**DEPARTMENT OF COMMUNITY DEVELOPMENT
Design Review Committee Agenda**

To: Design Review Committee
From: Jo Ann Hunter, Principal Planner
Date: September 26, 2016
Subject: COA-2016-00012 Page Audi

COA-2016-00012

Project: Audi Car Dealership (landscaping, site design, and lighting only)

WEST BROAD AUDI
 12592 BROAD STREET ROAD
LIGHTING PLAN - AREA 1
 DISTRICT 4
 GOCHLAND COUNTY, VIRGINIA

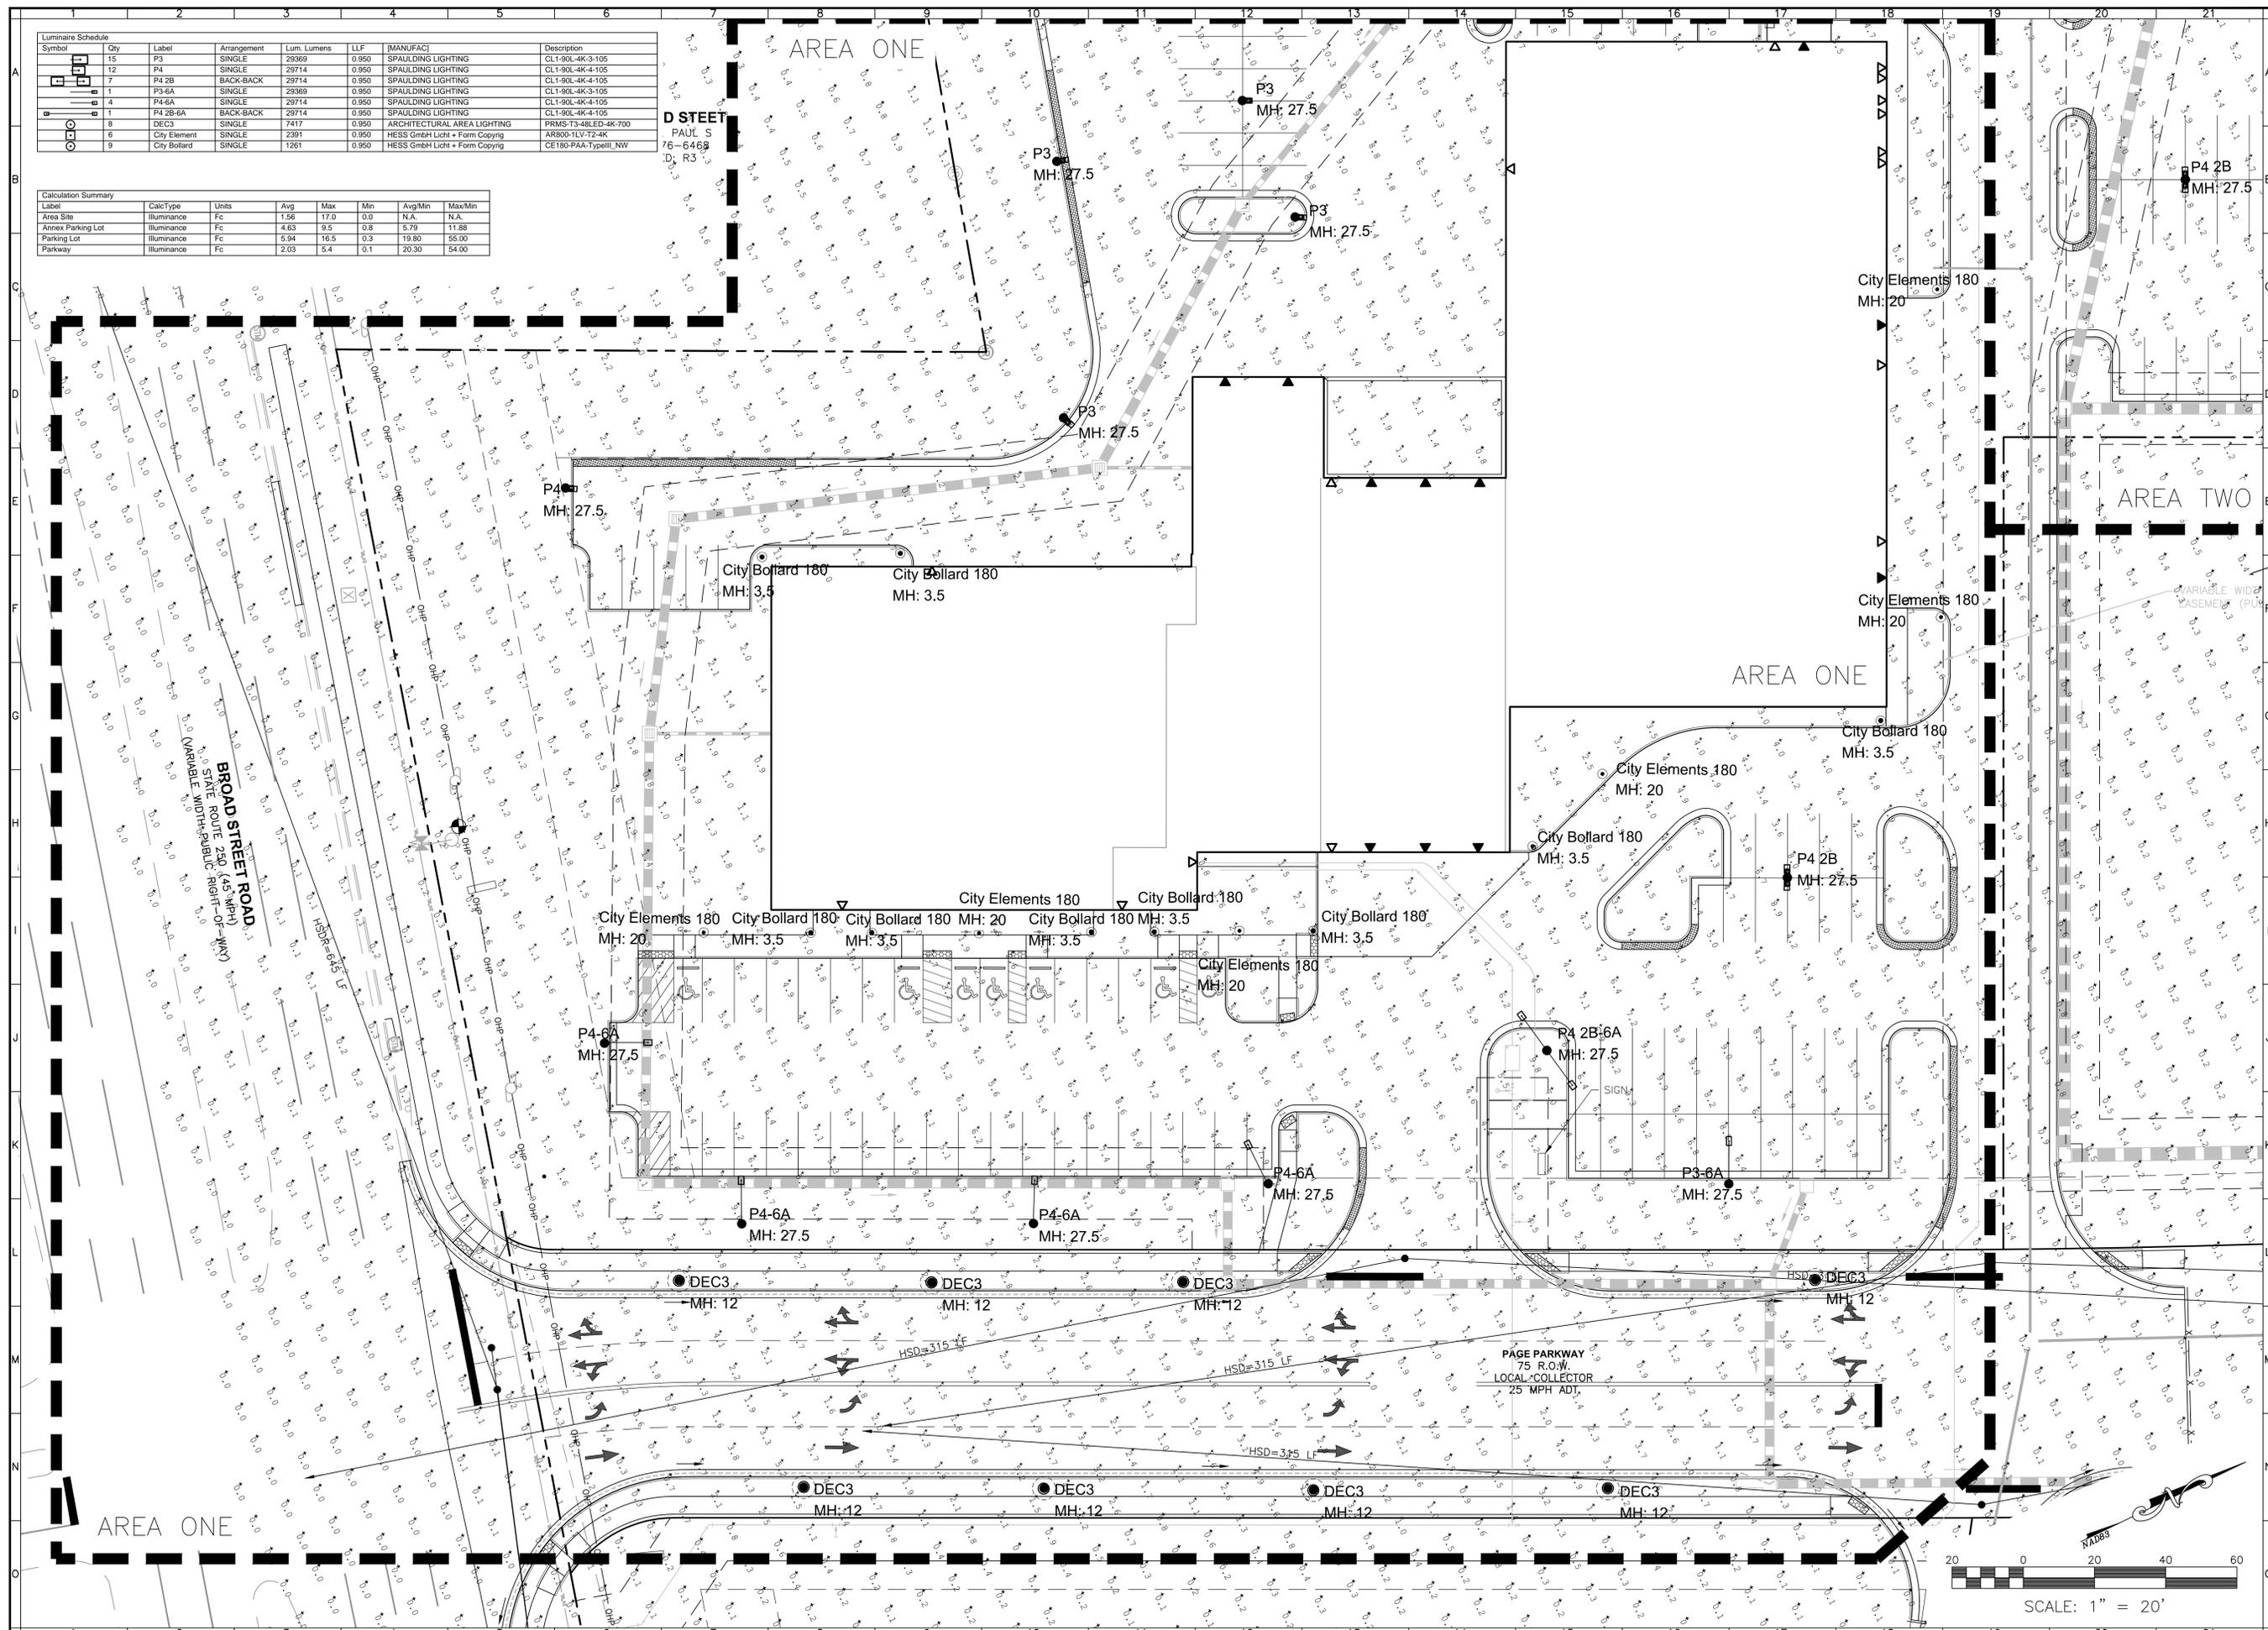
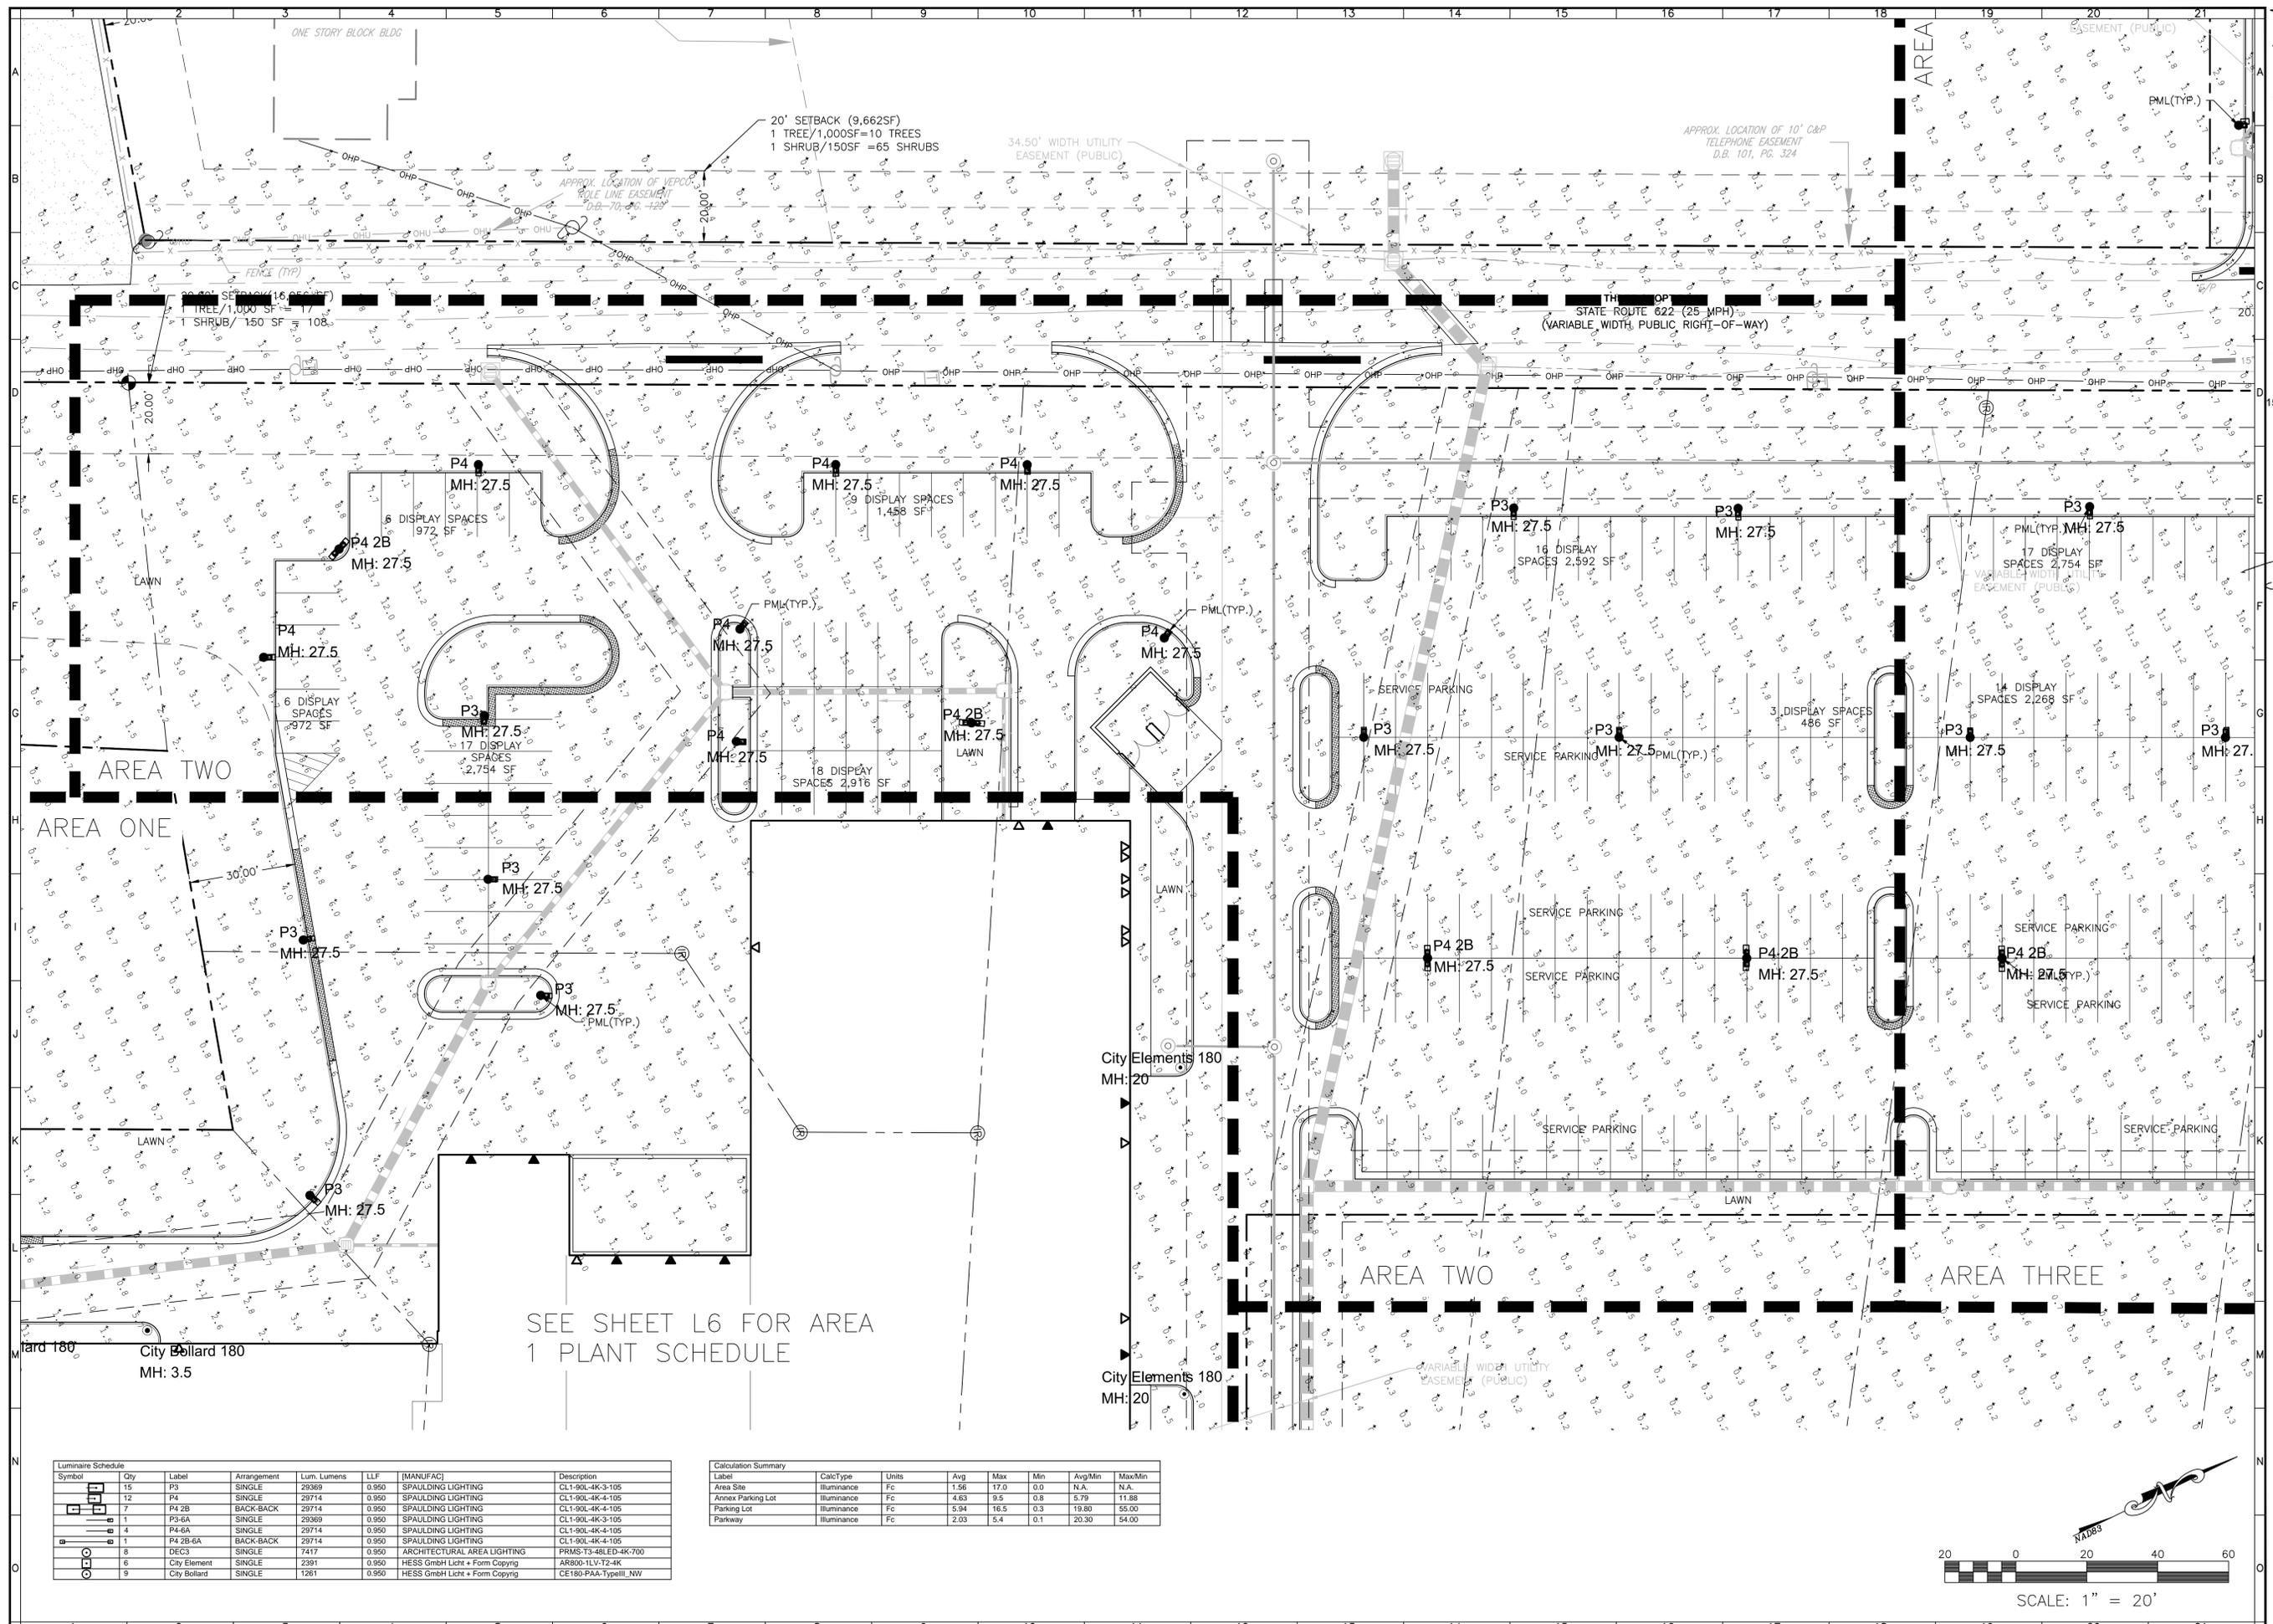
The County Code has a dark sky lighting ordinance. The applicant is proposing lighting fixtures that are approved by the International Dark Sky Association. The following revisions are required to meet Code requirements:

- Pole lighting must be reduced to 20'
- Light trespass cannot exceed .5 footcandle at all property lines

1. Improvements shall be in substantial conformance with the Landscape Plan submitted by Balzer and Associates dated 9/14/16 with revisions to the landscaping and lighting plan as discussed in this staff report.
2. Sign Package will be reviewed with a subsequent administrative Certificate of Approval application; however, sign base shall match the natural stone of the building.
